VSP-30
May 20, 1981

VENDOR SERVICE PUBLICATION

Subject: Bendix Service Bulletins 599A, 609A, 610,
613, 614

SERVICE BULLETIN NO. 599A
(Supersedes Service Bulletin No. 599)
Engineering Aspects are
FAA Approved

Figure 1. Terminology

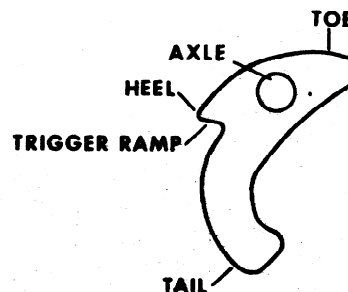
- a. Bend the end of a stiff wire into a right angle 1/8 inch long, maximum.
- b. Position impulse coupling so that heel of flyweight (see figure 1) is adjacent to stop pin. Reach

between cam and flyweight with bent wire, as near as possible to the stop pin, and pull outward on the flyweight as shown in figure 2.

Figure 2. Checking Flyweight to Stop Pin Clearance

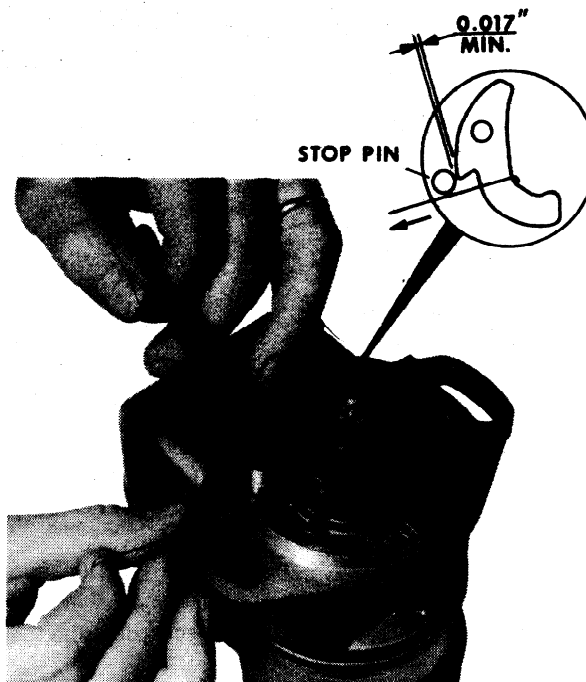
c. While pulling flyweight outward, insert feeler gages to measure the clearance between the heel of the flyweight and the stop pin, assuring a minimum of 0.017 inch exists.

d. If less than 0.017 inch clearance exists, this is cause for immediate rejection of the impulse coupling cam assembly, or possibly the entire impulse coupling. Refer to the applicable Magneto Overhaul Instructions for inspection procedures to determine if other impulse coupling parts are still serviceable.

Figure 6. Flyweight Tail Condition Check

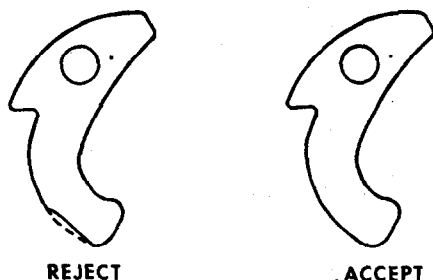
4. Flyweight tail condition must be given a visual examination to determine if flyweight is still serviceable. The surface at the apex of the beveled edge must blend smoothly with the outer contour of the flyweight. No flattening, denting or chipping is permissible. Any irregularity of this surface is cause for immediate rejection of the cam assembly. (See figure 6)

Figure 1.

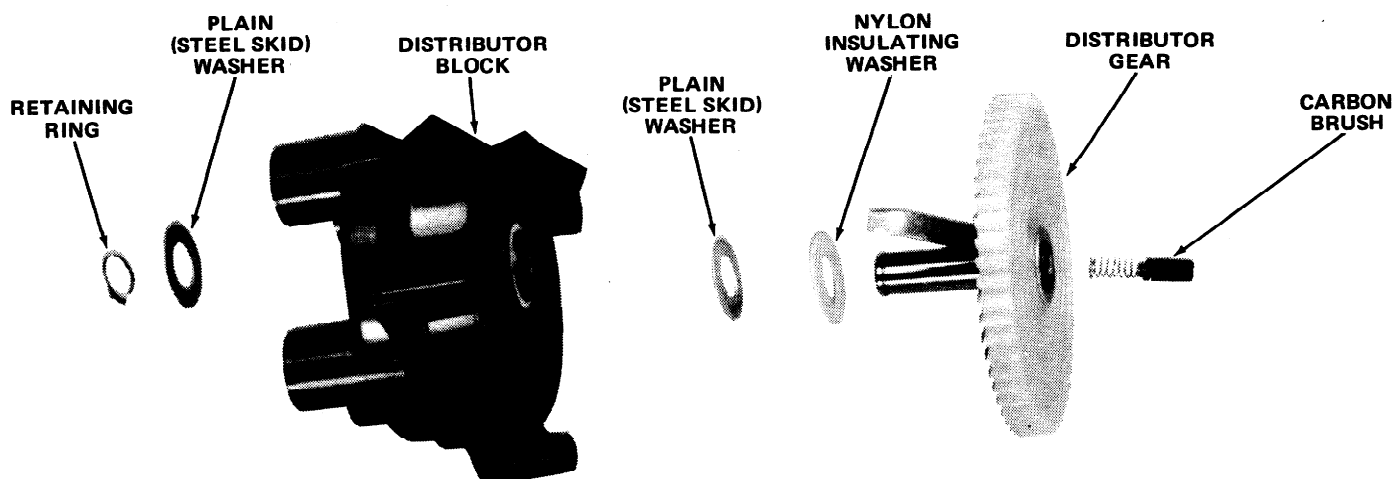
This bulletin announces availability of an improved, insulated distributor gear in kit form which is interchangeable between the D-2000/D-2200 & D-3000/D-3200 series magnetos. The kit includes all parts (except distributor block) as identified in figure 1.

Assembly sequence of the gear kit to distributor block is shown in Figure 1.

Figure 1. Location of Identification Mark

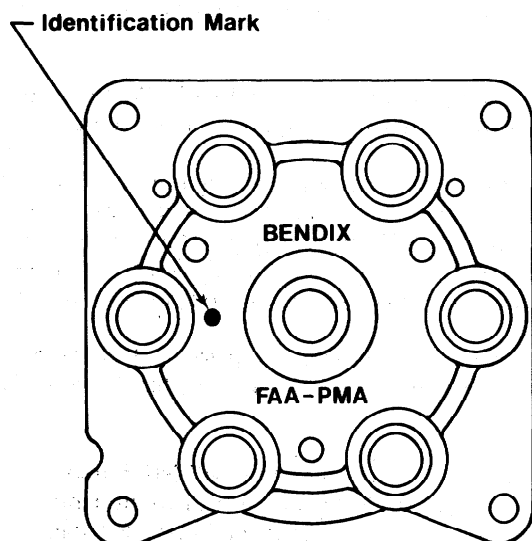
The new "Gripper Bushing" will eliminate the possibility of the bushing becoming loose. The "Gripper Bushing" block can be identified by a circular shaped mark 0.188 inch $\pm$ 0.031 inch in diameter raised 0.010 inch to 0.030 inch above the surface of the block. This mark is located on the tower side of the block, as indicated in figure 1.

Figure 6. Distributor Gear/Block Exploded View

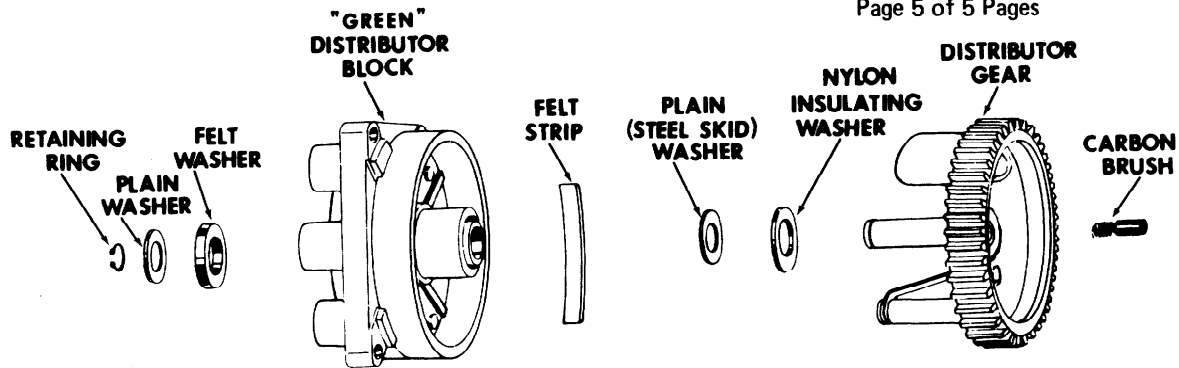
8. For reassembly, reference figure 6 and proceed as follows:

Figure 1 Defect

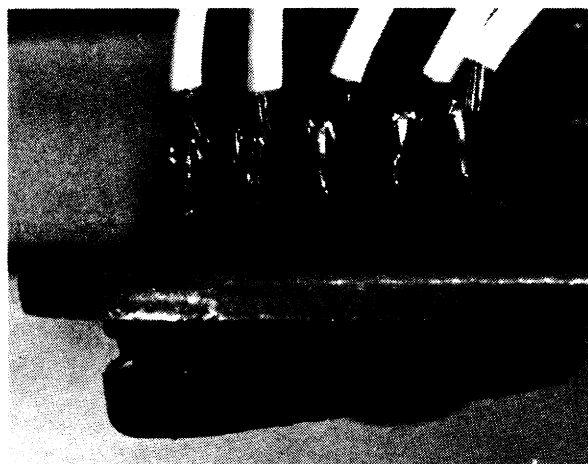
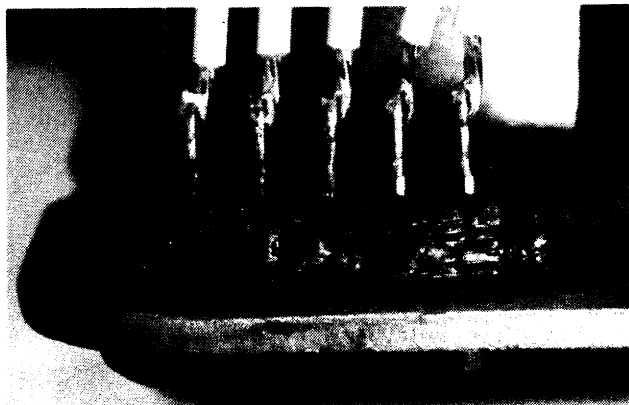
Bushing (connector), P/N 10-382943, may become loose in the vibrator plate and cause the grounding of both magnetos with possible loss of ignition. See figure 1 (defect).

5. Use RTV (Silicone rubber sealant, or equivalent, Dow Corning Corp., Midland, Mich. 48640) to seal terminal bushing to the mounting plate. Apply a small bead completely around the bottom of bushing to secure the bushing to the plate as shown in figure 2 (repaired). If RTV is not available, use either Hysol, Epoxi-Patch Kit (general purpose), Hysol Corp., Olean, NY or Conap, Easyepoxy Kit (K20 general purpose) 1405 Buffalo St., Olean, NY, or equivalent.

Figure 2 Repaired
